STAFF RECOMMENDATION

1809 Sweetbriar Avenue

August 15, 2012

Application: New construction – primary building and accessory building

ELEVATIONS 1

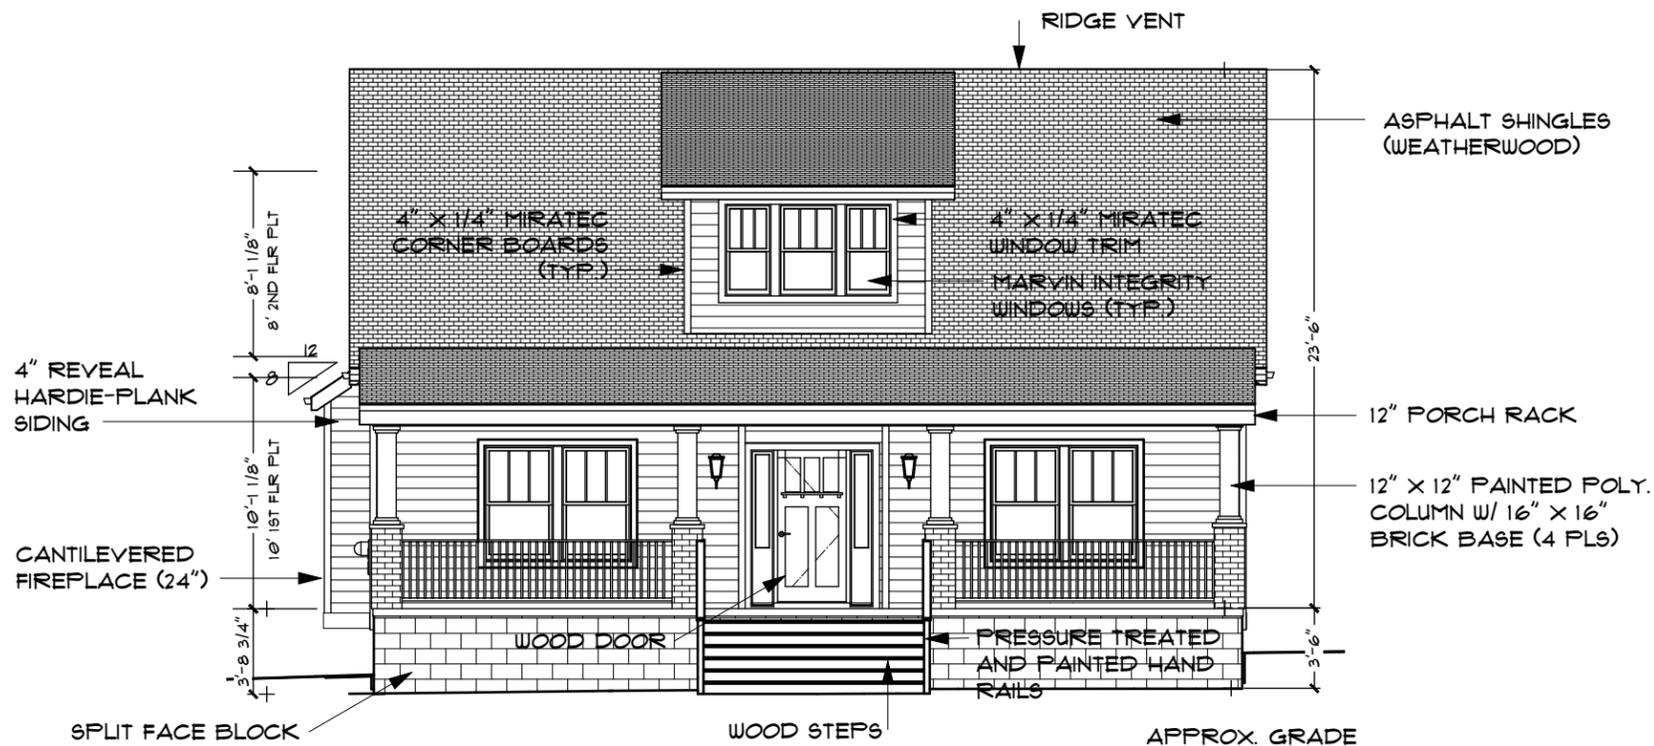
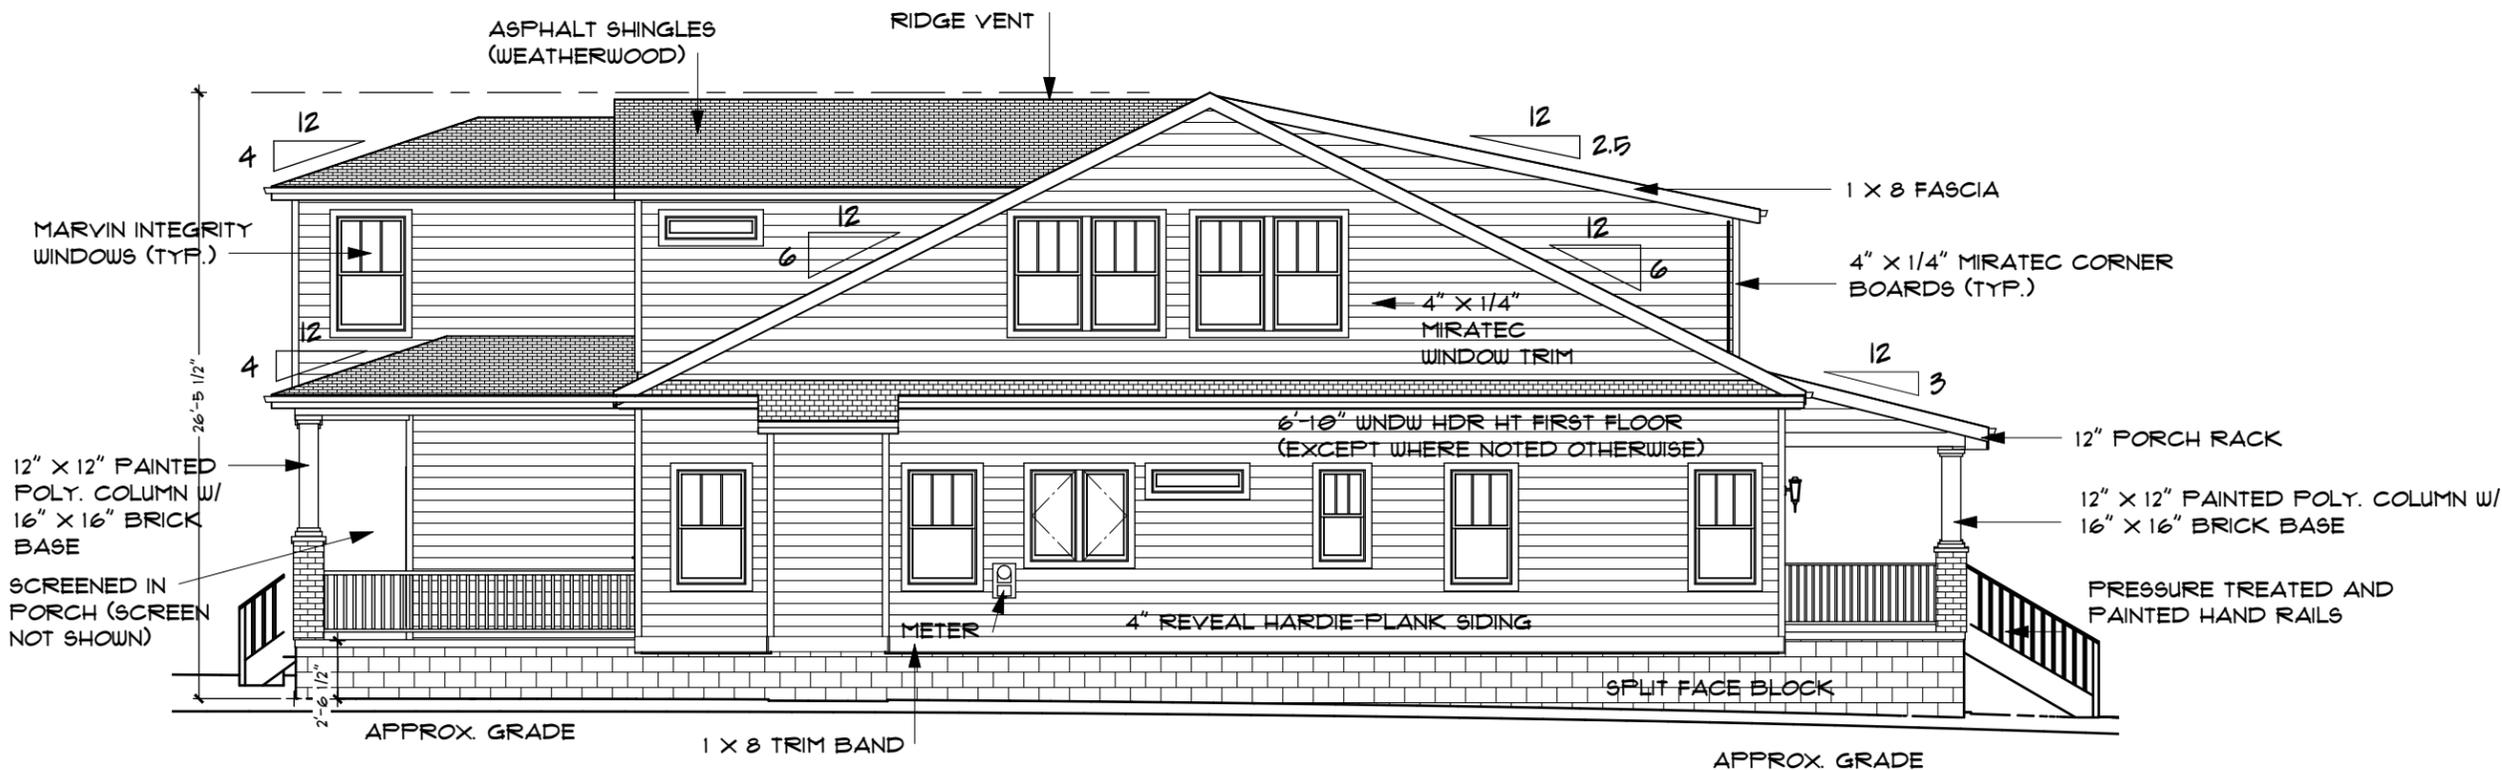
The proposed one and one-half story structure would have a maximum height of twenty-six feet (31') from existing grade, with a finished floor height of three feet, six inches (3'-6") from grade. The building's primary eave height at the front elevation will be thirteen feet, six inches (13'6") from grade.

Many of the houses on the 1800 and 1900 blocks of Sweetbriar represent the post-war development of the neighborhood and are unusually small compared to even modest homes of today's standards. They are primarily one to one and one-half stories with heights ranging from eighteen feet to twenty-four feet (18'-24') from grade. Because the massing of the structure will be primarily in the lower story with its bulk diminishing as the height increases because of the gabled roof, staff finds this height to be appropriate.

ELEVATIONS 1

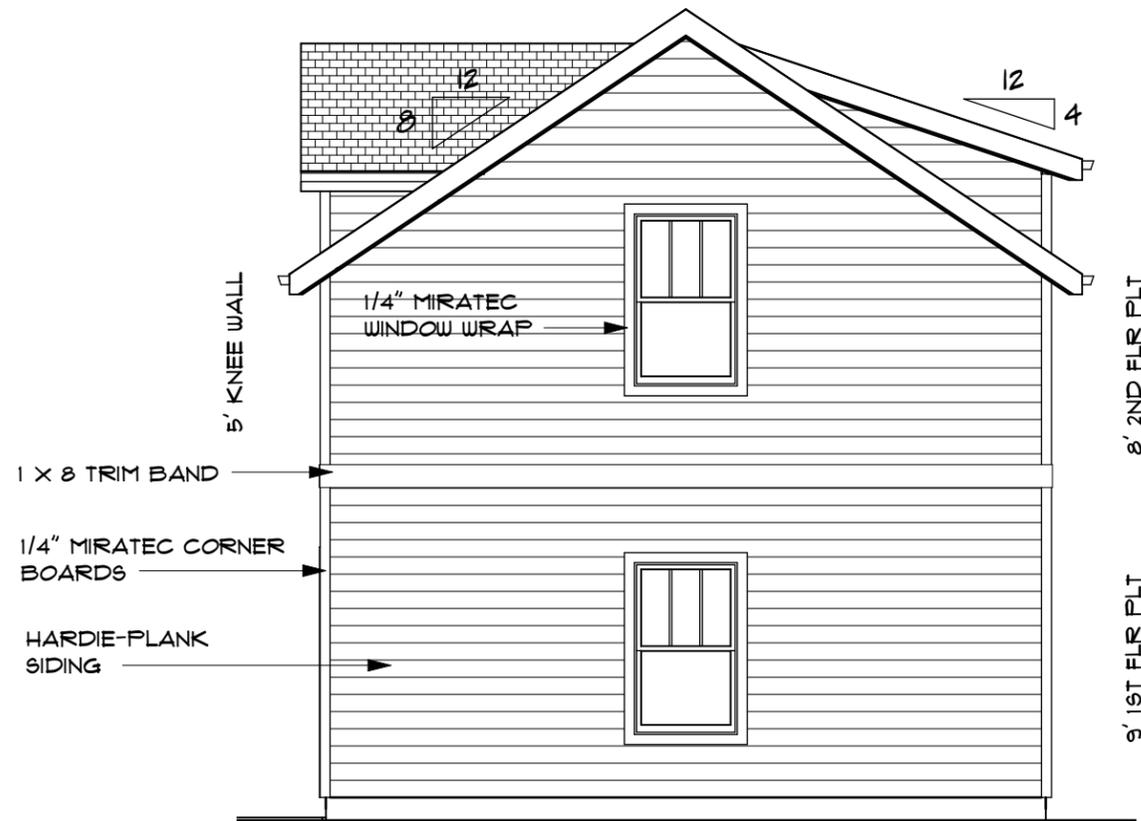
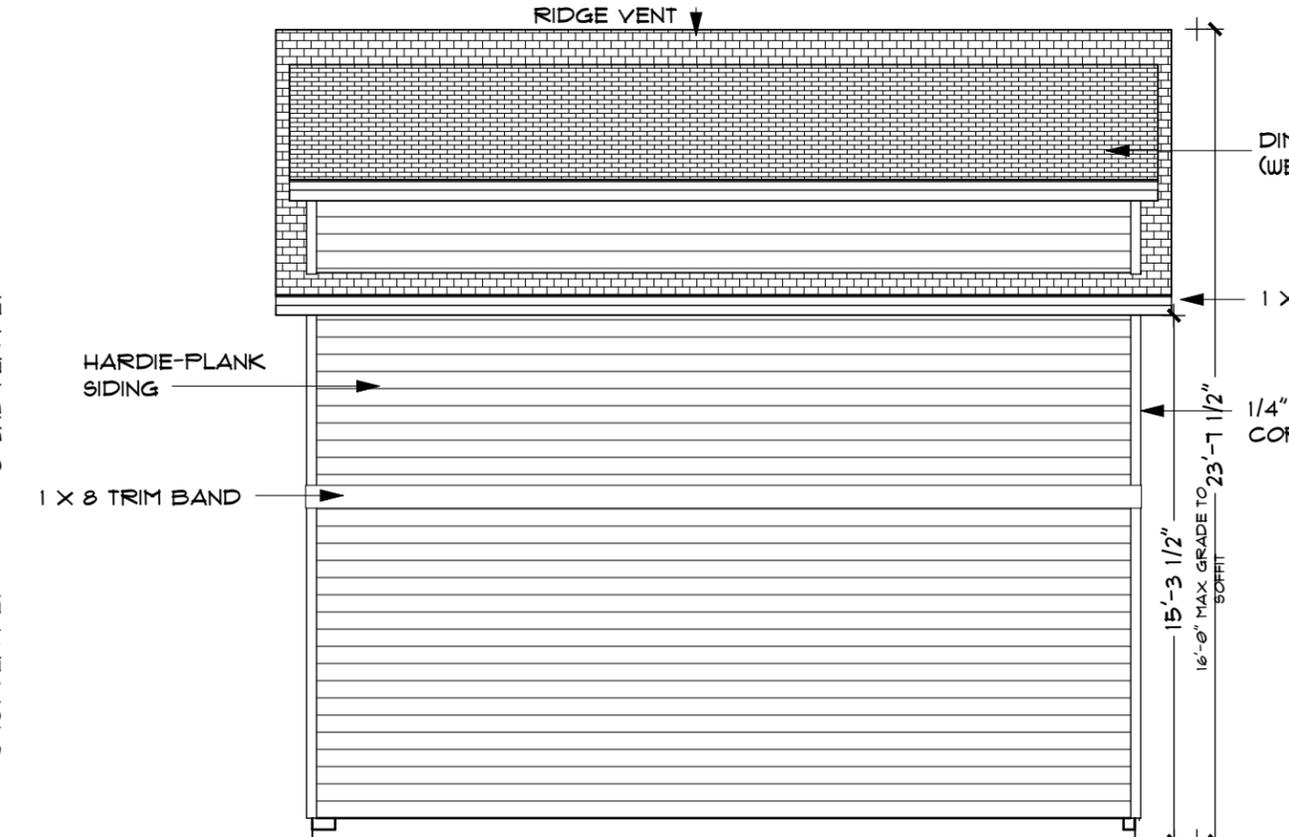
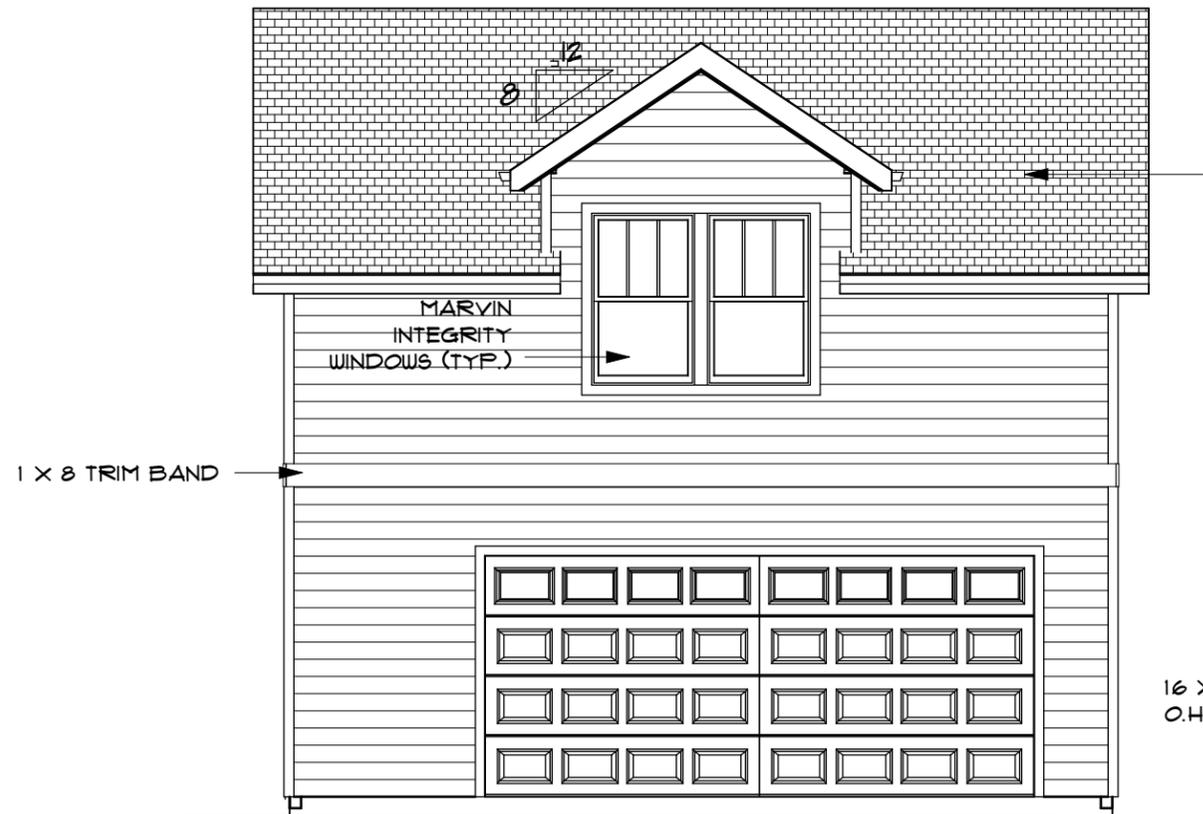
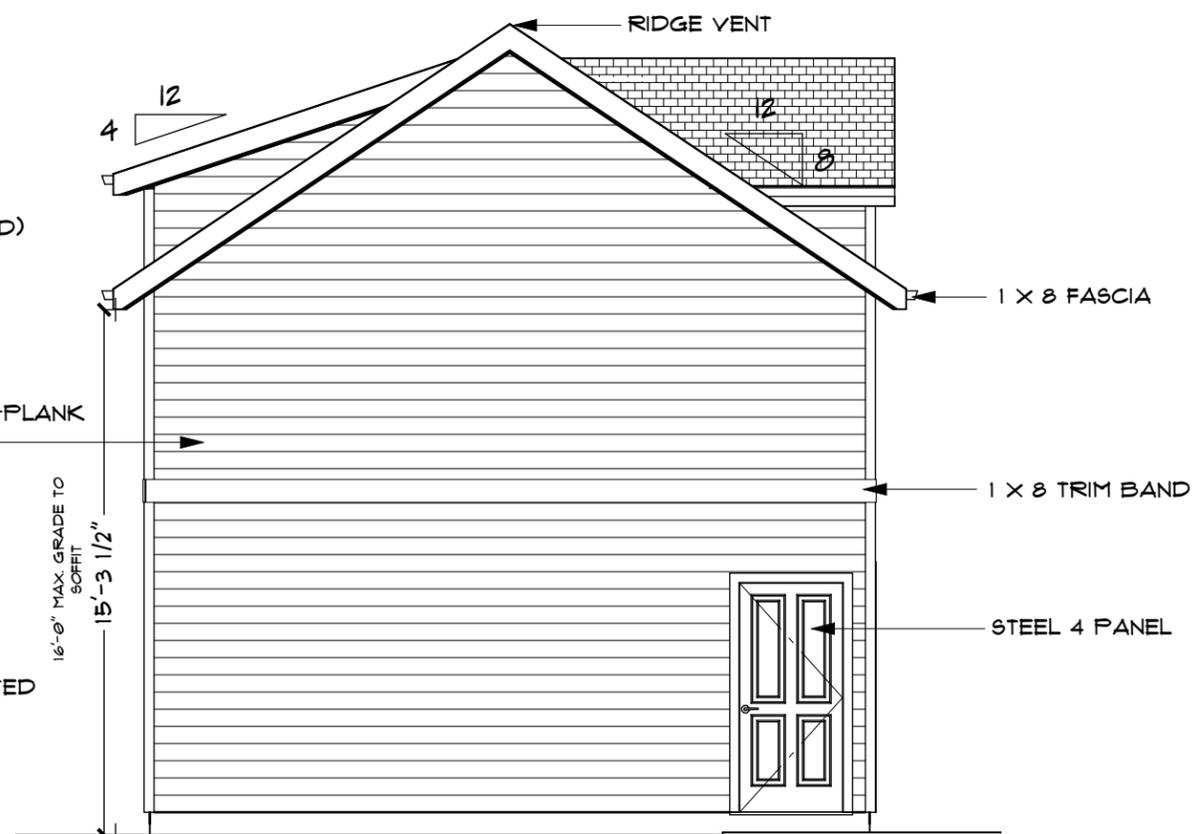
Because the building will face Sweetbriar Avenue, staff recommends that the building have two vehicle door bays instead of one large garage bay door.

The accessory structure is proposed to have an eave height of sixteen feet (16') and a ridge height of twenty-three feet, six inches (23'6"). Staff finds that the height of the accessory structure is not subordinate to the proposed new house, which will have an eave height of thirteen feet, six inches (13'6"). Moreover, the accessory building is not subordinate to the immediate historic context, where the primary structures range in height from eighteen feet to twenty-four feet (18'24'). Staff asks that the ridge height be lowered to approximately twenty feet (20') from grade and that the eave height be lowered by a minimum of two feet (2') so as to be subordinate to the infill and to the neighborhood context.

With the reduction of the ridge height to a maximum of twenty feet (20'), the lowering of the eave height by a minimum of two feet (2'), staff finds that the proposed accessory building meets Section II.B.1.i. of the design guidelines.
